**SUBJECT:** Invitation for Bid #10-3612-OV  
Lincoln Park Splash Pad & Restroom Pavilion  
501 17<sup>th</sup> Street East, Palmetto, FL

## ADDENDUM #1

**Ugarte & Associates, Inc. Memorandum dated November 10, 2010** responding to questions received at the Pre-Bid / Information Conference held on October 20, 2010 and questions received from contractors and suppliers through November 5, 2010. Ugarte Memorandum lists all revised drawings, Health Department Comments and revised submission sketches which are made a part of this Addendum No. 1. (42 Total Pages)

CIVIL SITE PLAN

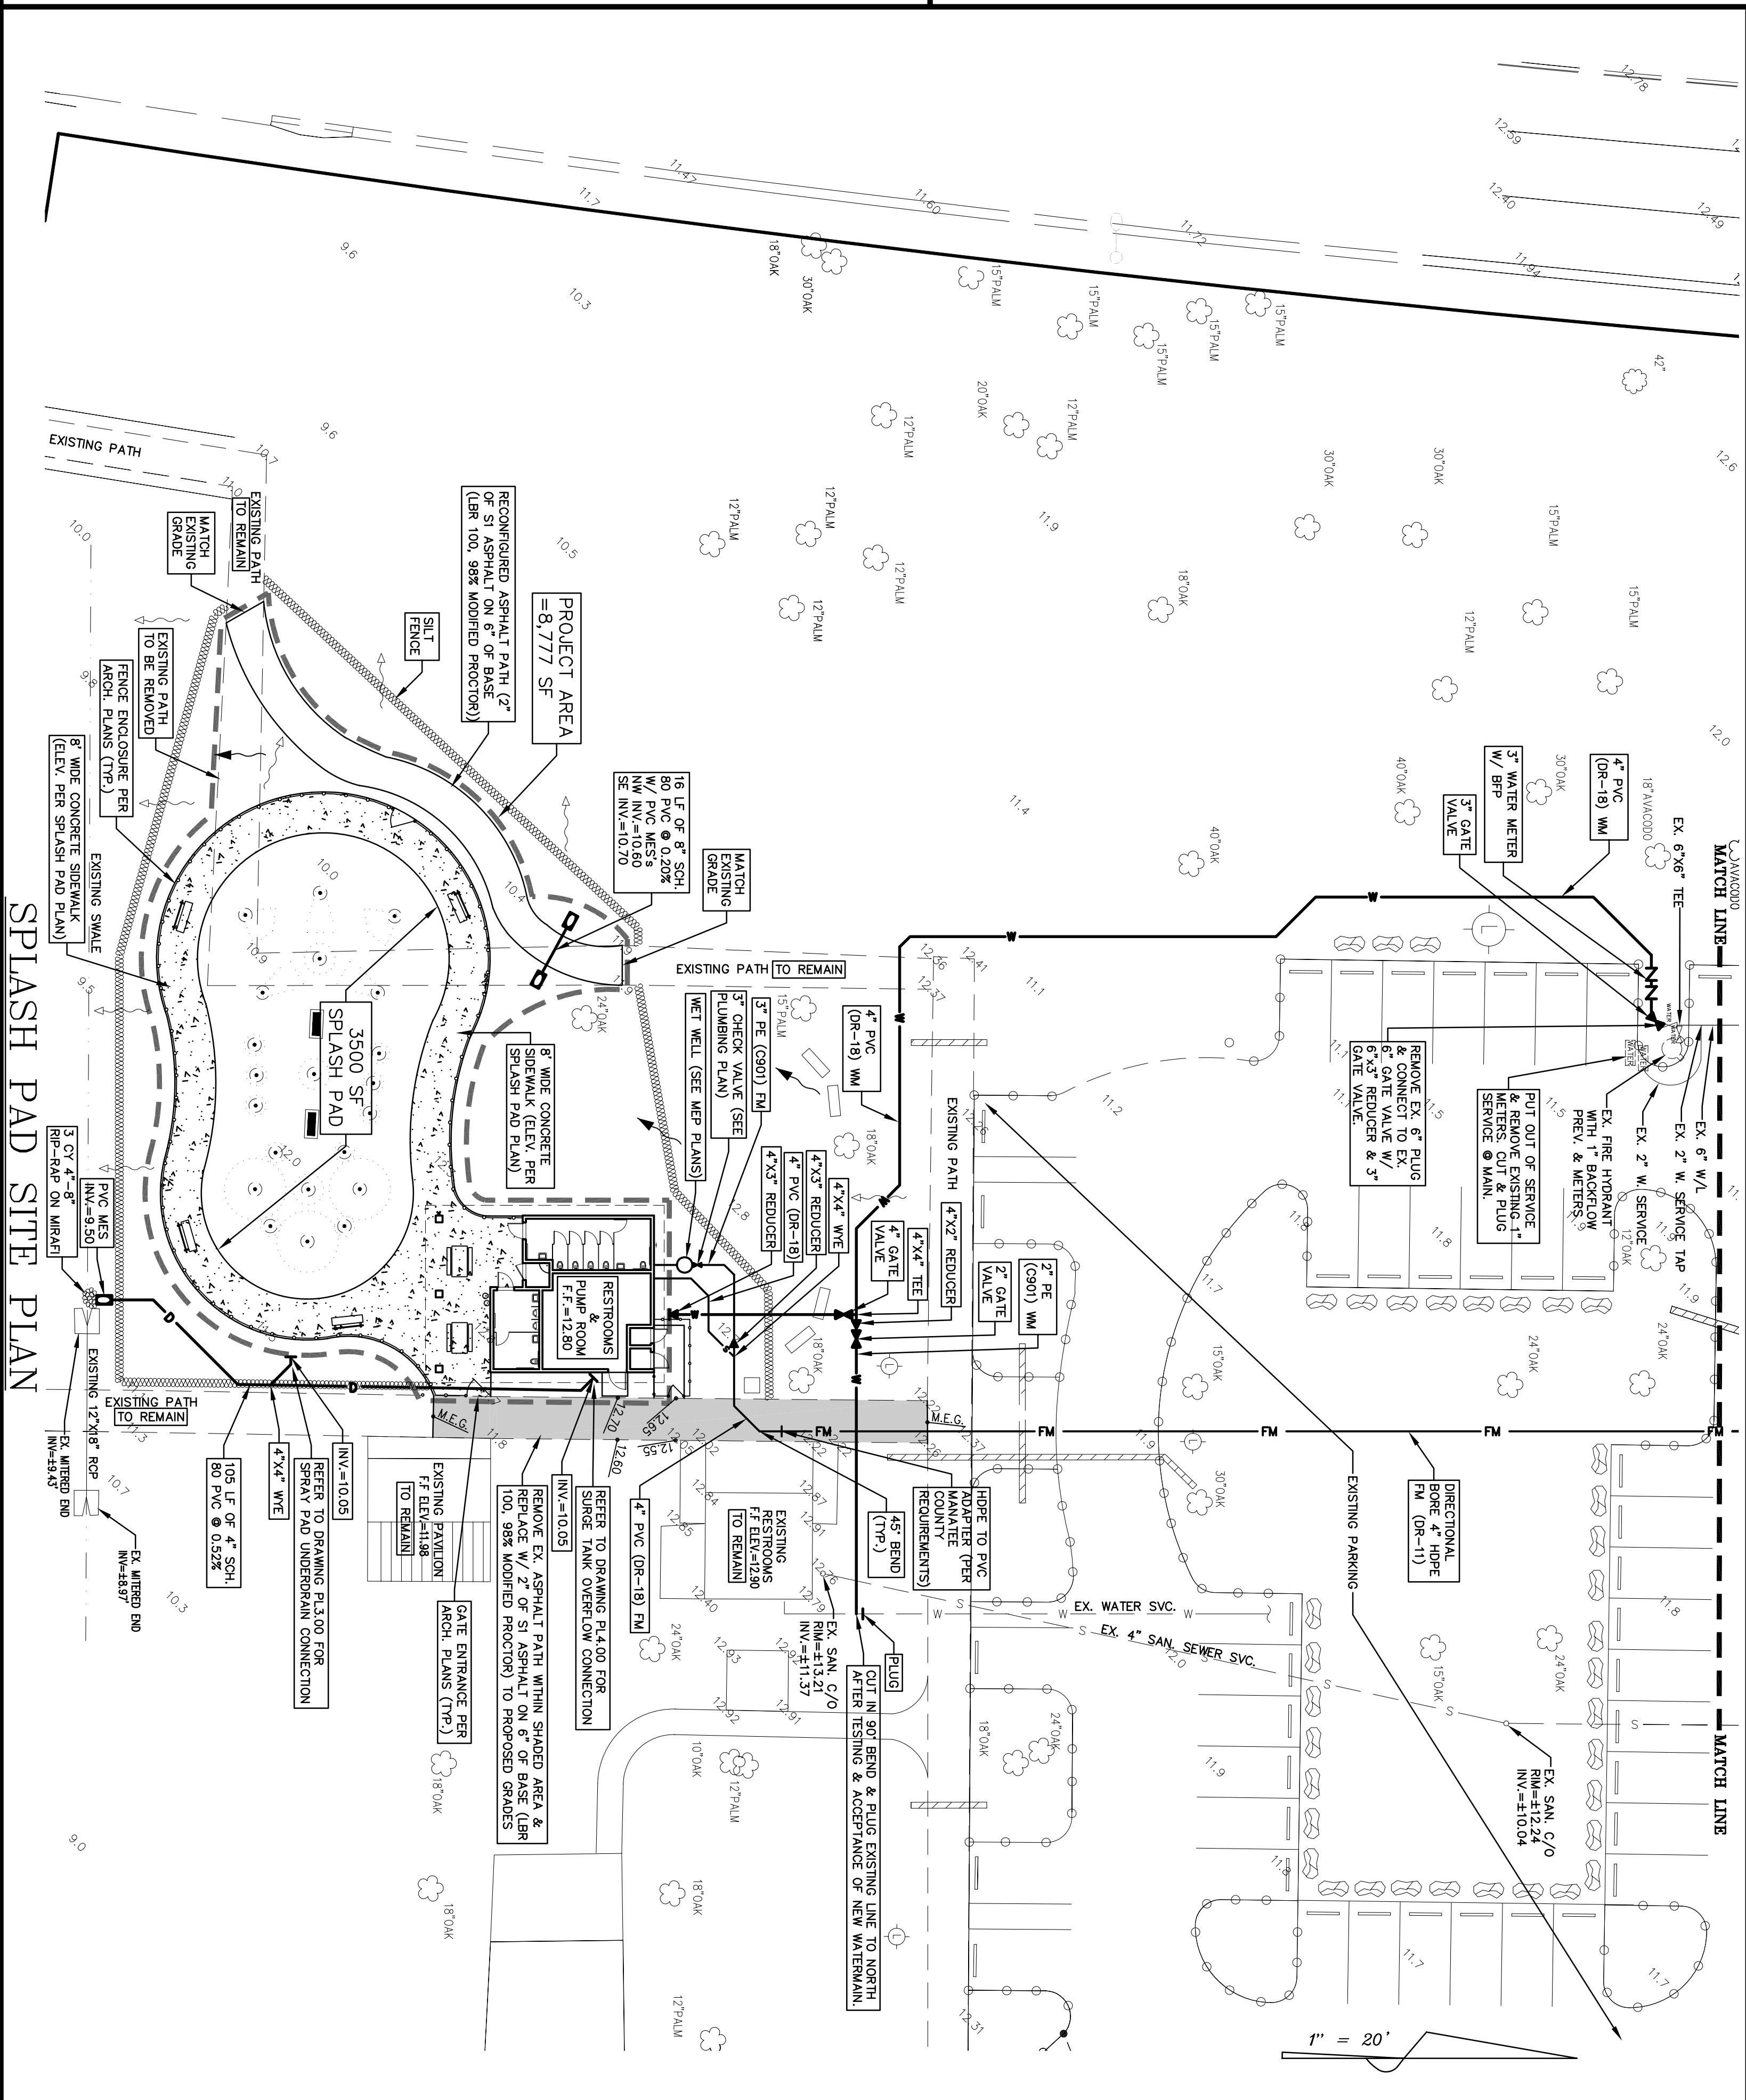
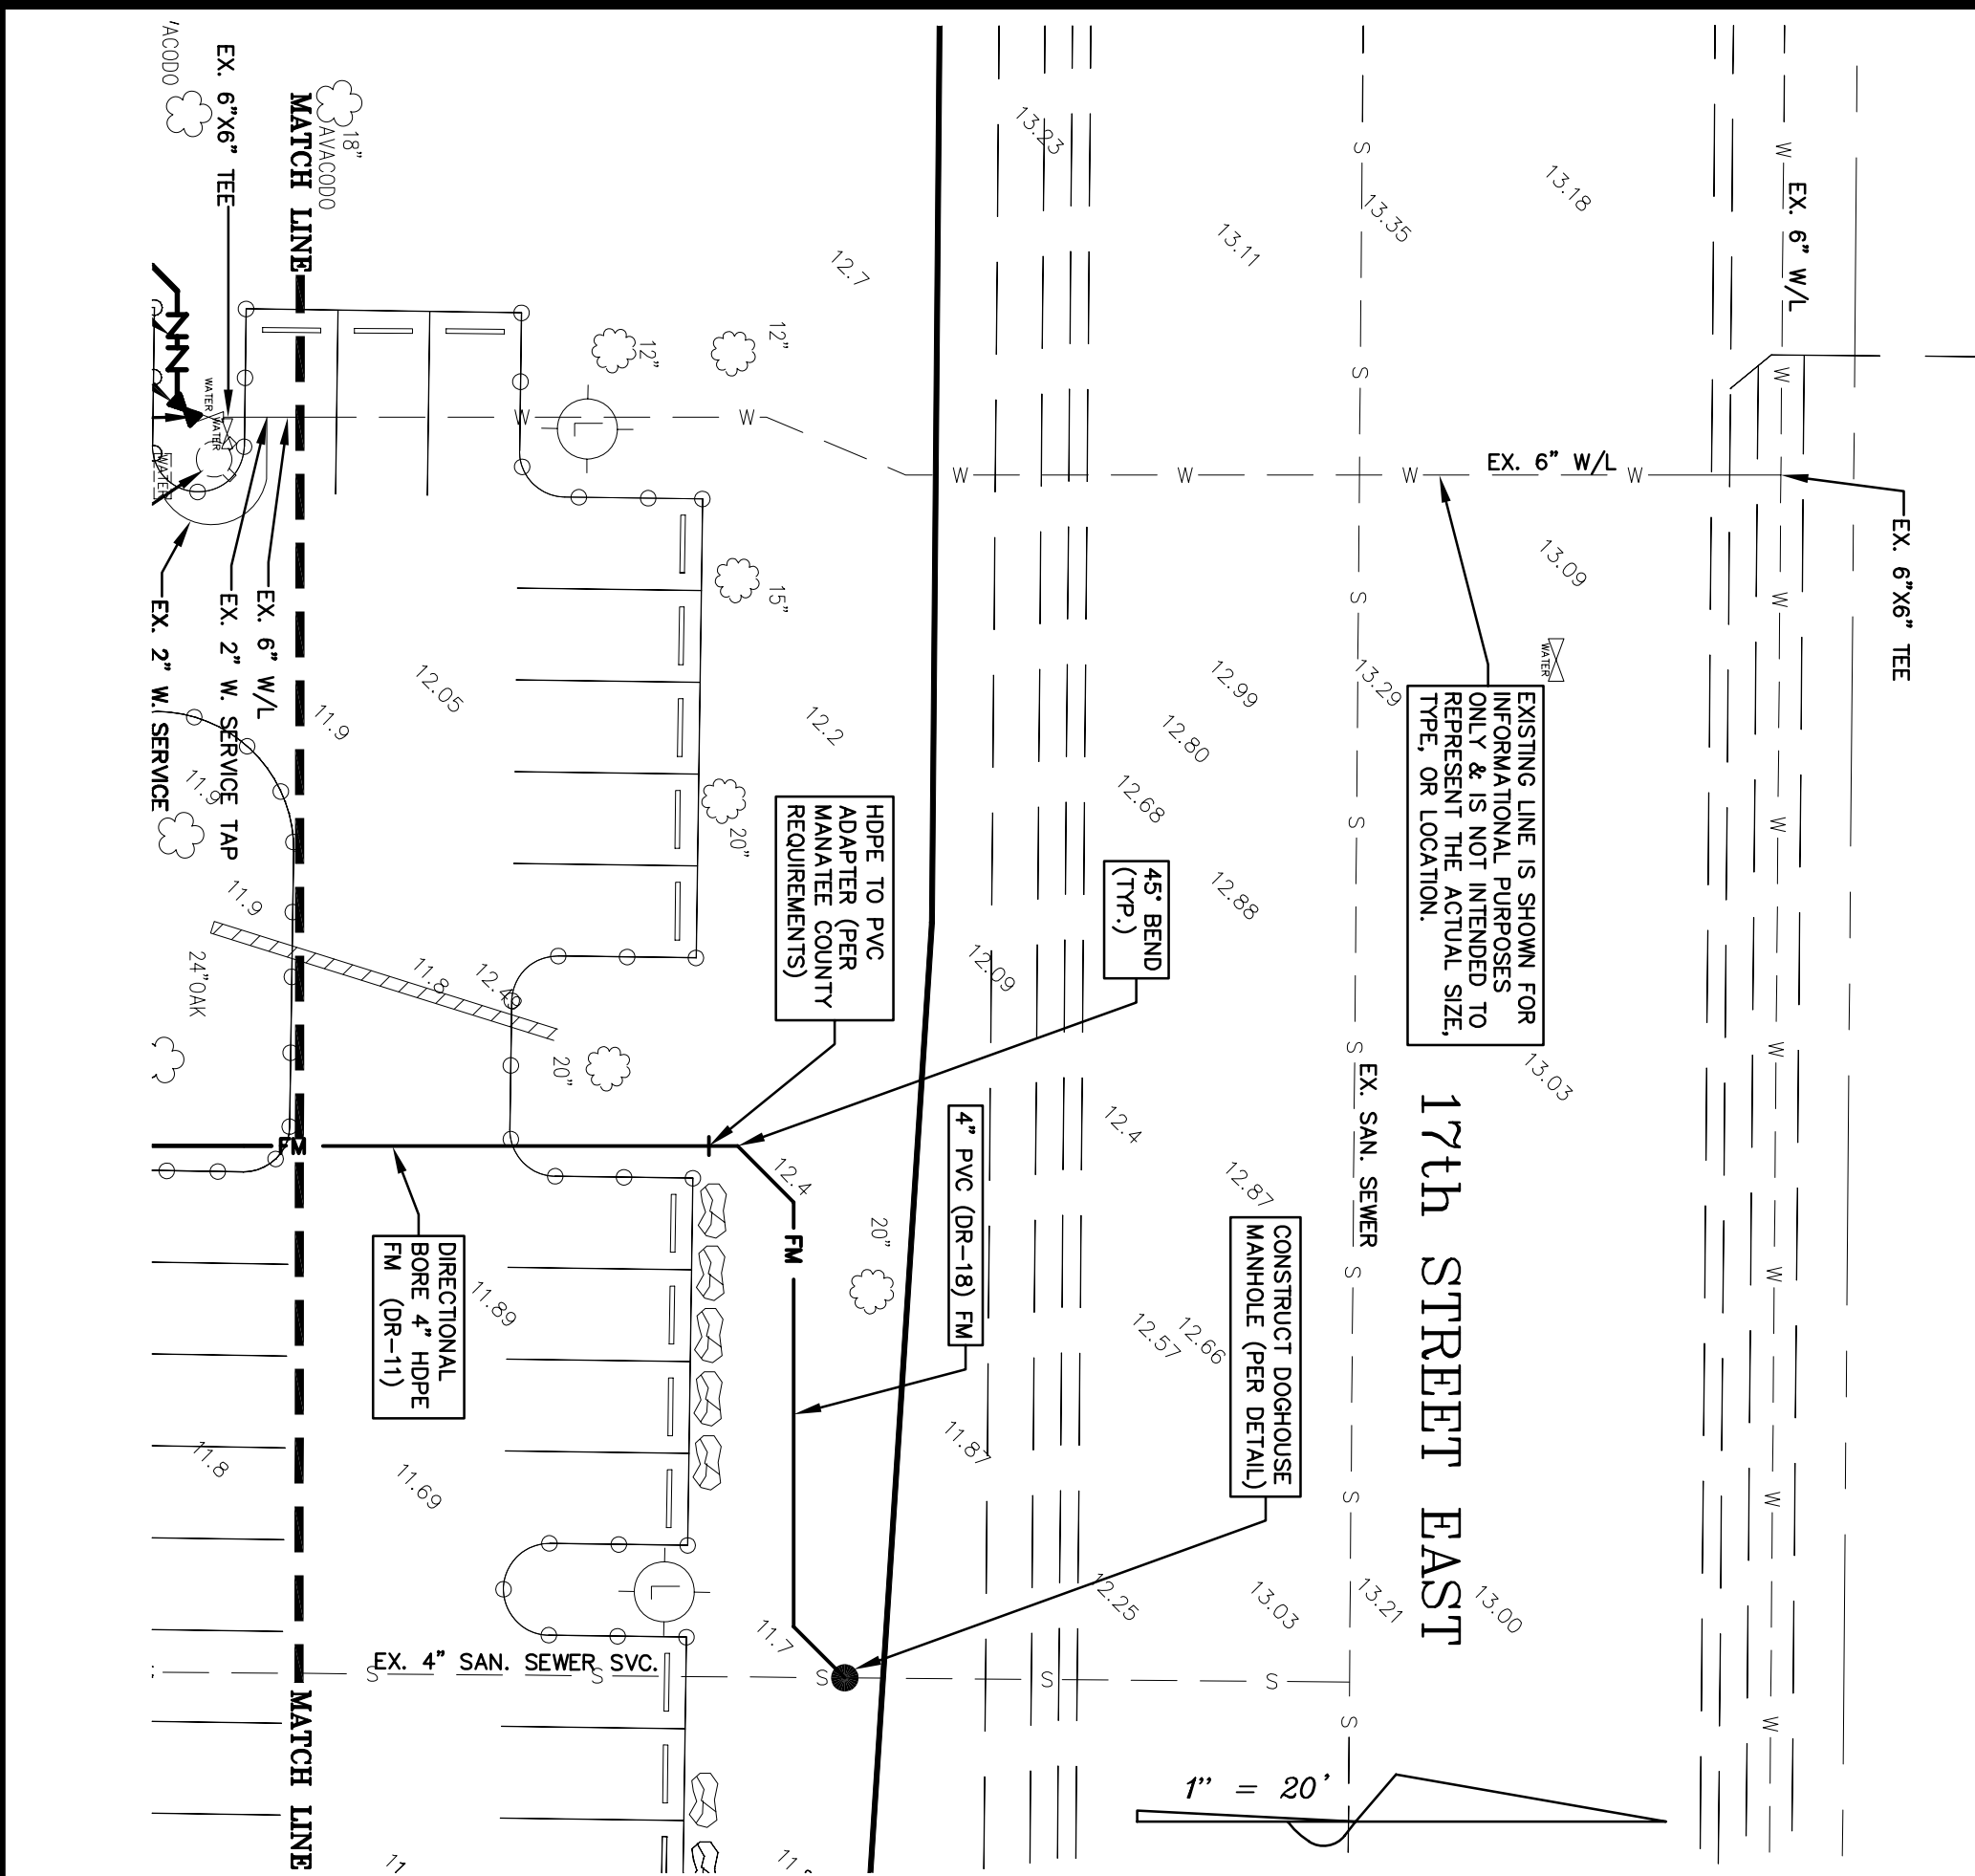
**RFI Question #1:** On the civil site plan there is a 4" wet tap required on the existing water main for the installation of the new 4" water main. On that drawing there is no gate valve called out on the new 4" pvc run between the BFP/Meter assembly and wet tap. On the Notes & Details drawing there is a gate valve shown under the detail for the 3" Water Meter w/ Backflow Preventer. It is shown between the main and new BFP assembly. Is this valve required in addition to the valve at the wet tap?

**RFI Question #2:** On the civil site drawing there is a note that says, "All underground work to be hand dug." Will that apply to the 300' of 4" water main? I would assume that this does not apply to the cast in place concrete water tank, or does it?

**RFI Response #1:** Civil site plan C1 Addendum 1 and corresponding Civil Sheets the wet tap, water meter and backflow preventer have been revised by the Manatee County Utility Department. Package Sewer System is included in Sheet P201 Addendum 1.

**RFI Response #2:** The intent of the hand digging note on the Civil drawing is to minimize damage to the roots of the existing trees by new plumbing line installations. This note applies to the water main extension. Please note that In Addendum #1 Sheet C1 indicates directional boring for certain segments. This does not apply to the cast-in-place concrete surge tank.

SKPL5.10-1

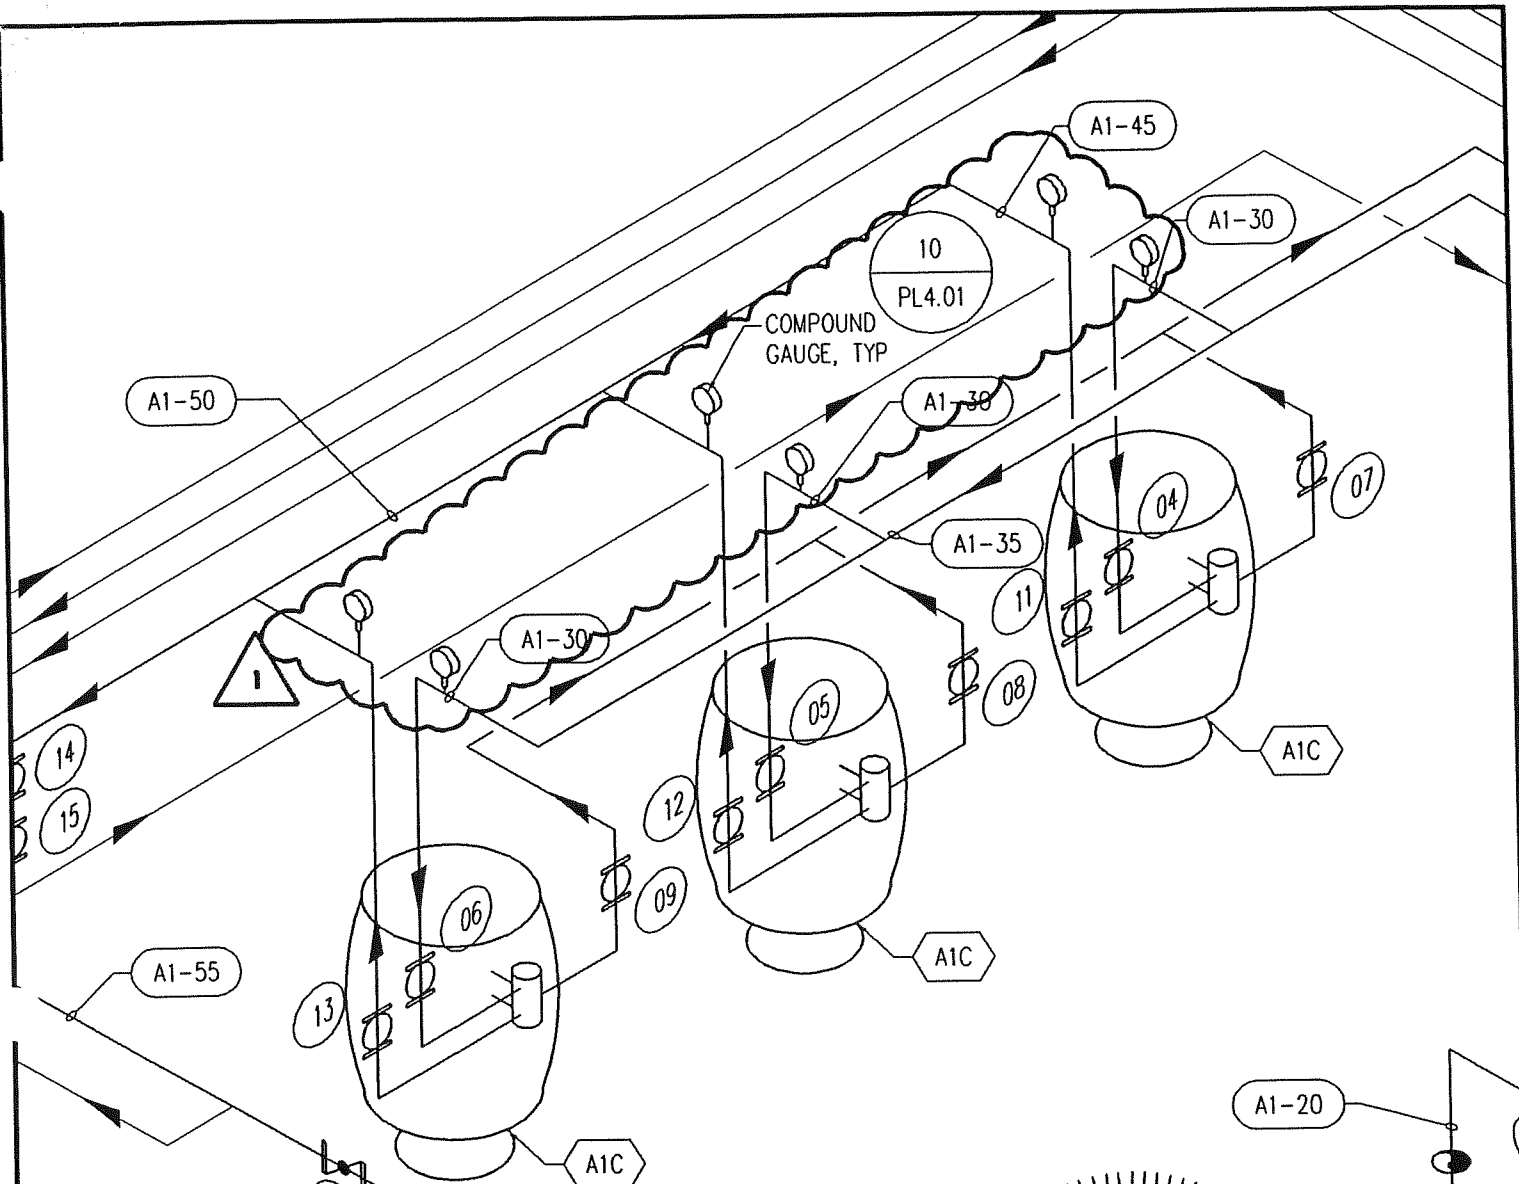
7. A Pulsar one chlorine injection system has been specified in lieu of the Hayward system to comply with 64E-9.007(16) with chemical loop and venturi system. Please see attached sketch **#SKPL5.10-1, #SKPL5.10-3, #SKPL5.10-4, #SKPL4.02-8** and revised equipment list on sketch **#SKPL4.00-4**.
8. The UV validation certificate and additional information has been attached to this submittal package for your reference and are in compliance with 64E-9.007(16)(f)3.
9. The UV equipment specified is in compliance with 64E-9.007(16)(f)(4). A note has been added to the UV equipment list as shown on attached Sketch **#SKPL4.00-4**
